**MODIFICATION REQUEST:
MP10_0016 MOD 2**

***Scottish Hospital Seniors Housing and
Care Facility***

Environmental Assessment Report
Section 75W of the *Environmental Planning and
Assessment Act 1979*

April 2017

Figure 10: West Elevation Brown Street Plan. (Source: S75W modification request)

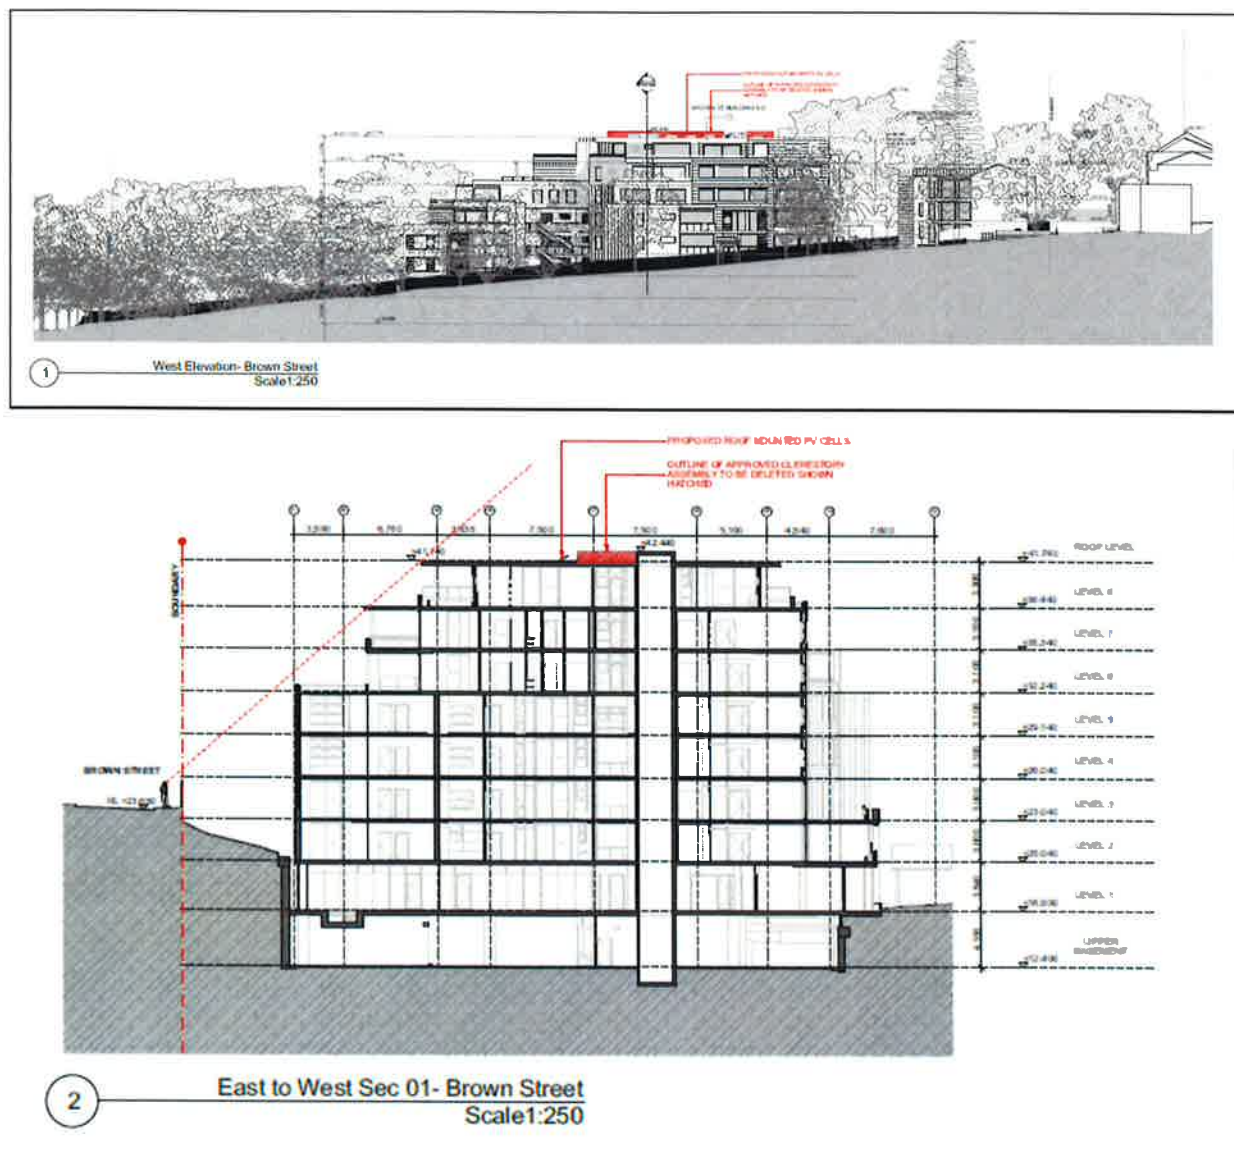
The Proponent is seeking to install photovoltaic cells on the roof of the Brown Street ILU building to achieve BASIX energy efficiency requirements (**Figure 10**).

Public submissions raised concerns that the photovoltaic cells would be visible from the public domain area of the Heritage Conservation Area. In its RtS, the Proponent has submitted an elevation showing that the photovoltaic cells will not be visible from the public domain.

The Stephen Street RACF and Brown Street ILU building, as approved, provide clerestory windows. The Proponent is proposing partial deletion of the clerestory windows on the Stephen

Street RACF Building and deletion of all of the clerestory windows on the Brown Street ILU building (as shown in **Figure 10**).

The Proponent is seeking to remove the clerestory windows as they do not provide any purpose or provide any sunlight benefit to the upper level residences. Deletion of this element would also provide additional thermal and acoustic benefits to the apartments below and reduce maintenance costs for the building.

The Department notes that clerestory windows are typically provided in order to maintain privacy while allowing for natural lighting within the building. However in each of the upper level residences would have standard room windows and would not rely on the clerestory window for daylight. The approved windows therefore do not provide any purpose and upper residences will still receive good solar access once the windows have been removed.

The Department has reviewed the relevant information and is satisfied that the Proponent has adequately demonstrated that the photovoltaic cells will not be visible from the public domain. Considering that the photovoltaic cells are required to achieve BASIX requirements and will not have any impact to the streetscape, the Department supports its use on the Brown Street ILU roof.

The Department supports the deletion of the clerestory windows and is satisfied that there will be no reduction in the overall design quality of the building.

Figure 11: West Elevation Brown Street Plan. (Source: S75W modification request)

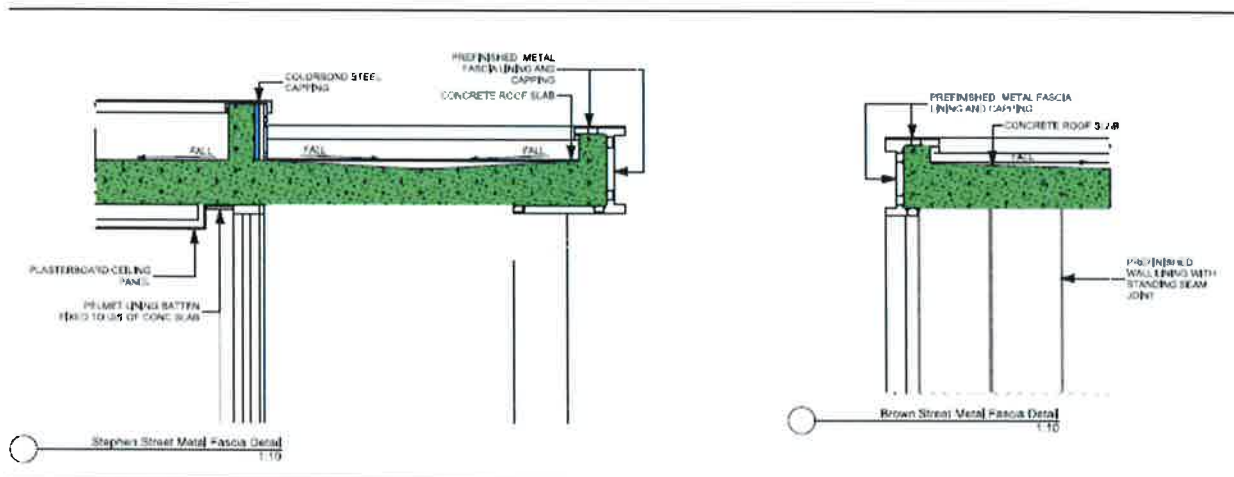
The Proponent proposes to replace the approved metal roof of both the Brown Street ILU and Stephen Street RACF/ILU buildings with a concrete slab (**Figure 11**). The Proponent contends that this change in material will improve the longevity of the structure due to the site's proximity to the salt water of Sydney Harbour, as well as acoustic and thermal performance. It will also ensure ease of access to the roof for maintenance purposes. The return fascias on the building elevations will remain clad in metal in order to maintain the appearance of a metal roof when viewed from the public domain.

The Department accepts the Proponent's justification for the change in roof material. The Department supports this aspect of the proposal as the use of cement will provide greater structural integrity to the roof, and the cladding of the fascias will ensure the buildings retain the appearance of a metal roof when viewed from the public domain.
